CITY OF ALBUQUERQUE

**RE: Age Restricted Housing
Grading and Drainage Plan
Engineer's Stamp Date: 04/06/18
Hydrology File: D18D056A**

| ENGINEER'S SEAL RONALD R. BOHANNAN P.E. #7868 | OVERTURE SENIOR ACTIVE ADULT GRADING AND DRAINAGE PLAN | DRAWN BY DY |

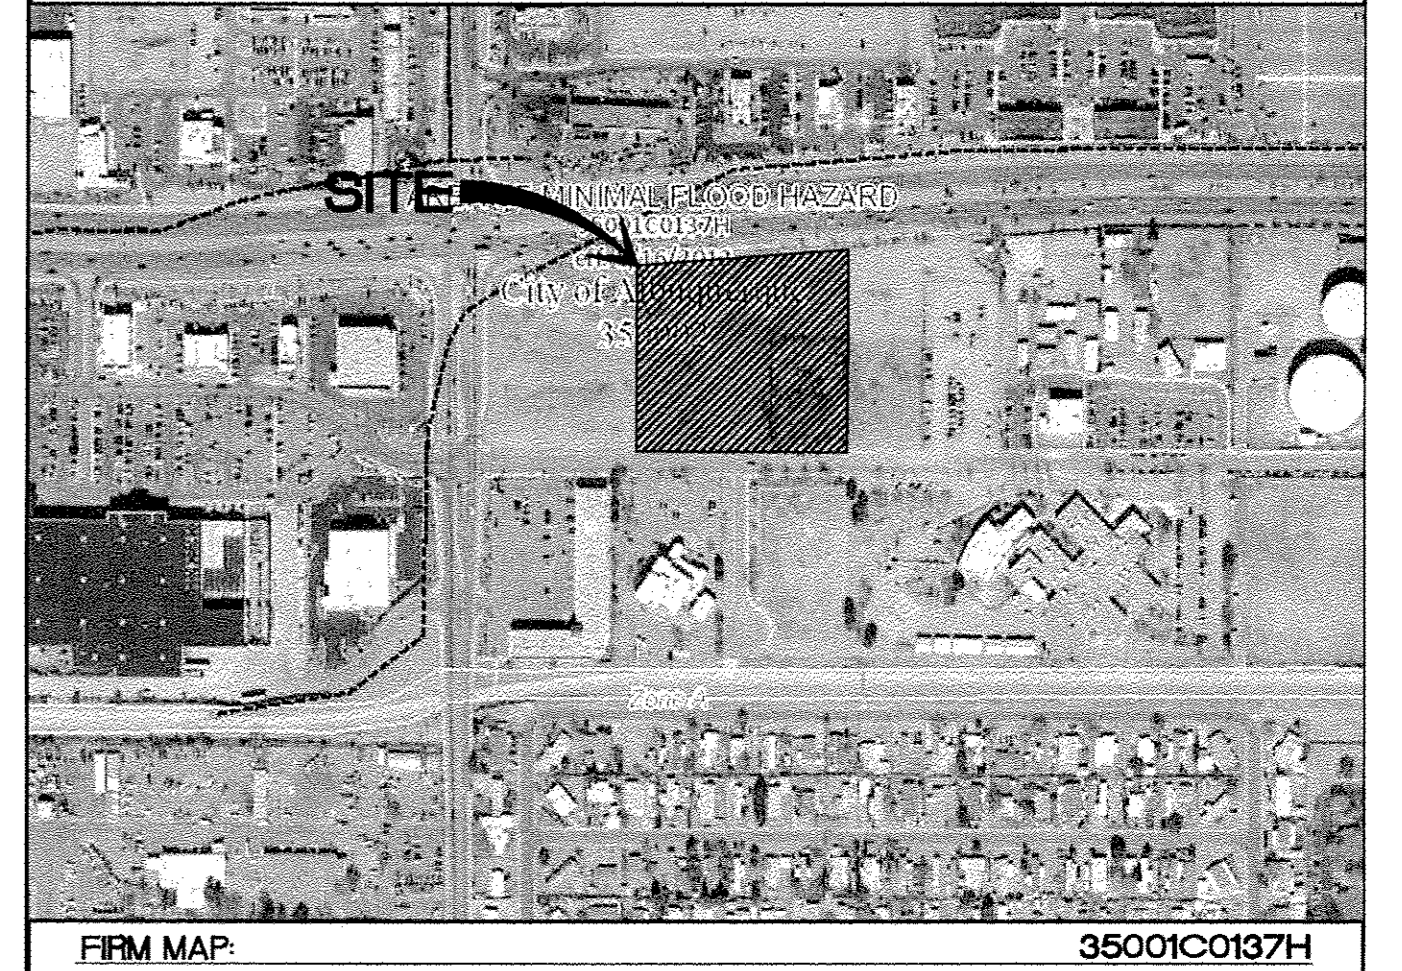
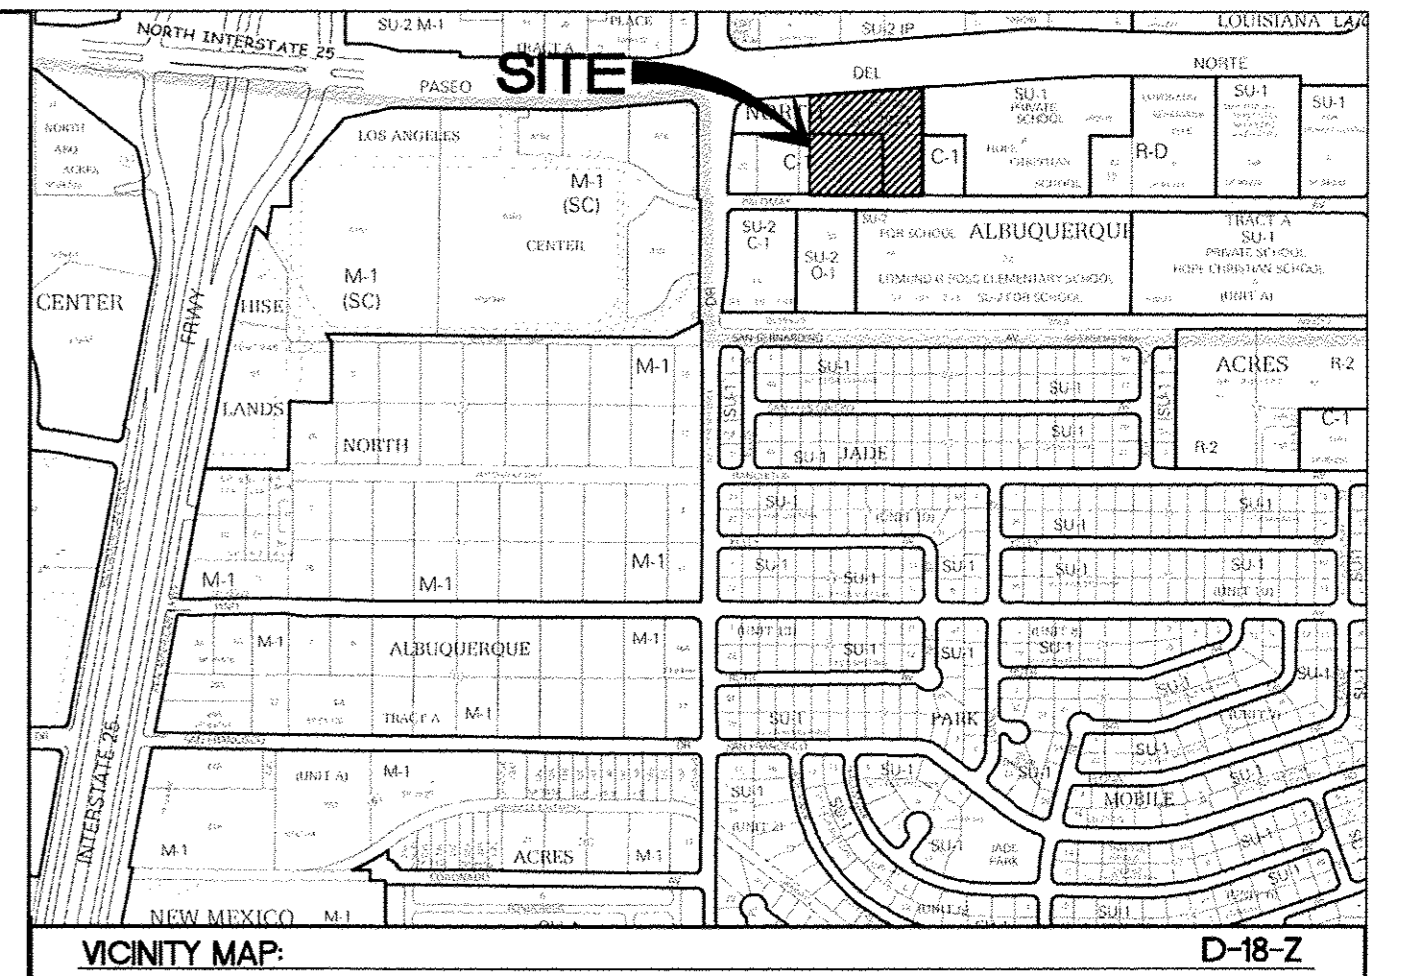
Based upon the information provided in your submittal received 04/06/2018, the Grading and Drainage Plan is approved for action by the DRB on the Site Plan for Building Permit.

As a reminder, please provide a Private Facility Drainage Covenant per Chapter 17 of the DPM for the first flush ponds (Stormtech chambers) prior to Building Permit approval. Also the site currently shows more than 1 acre of disturbance is being proposed. An Erosion and Sediment Control Plan is required and has to be submitted to the storm water quality engineer (Curtis Cherne, PE, ccherne@cabq.gov). Hydrology's approval for Building Permit will not be given until the submittal of the ESC Plan.
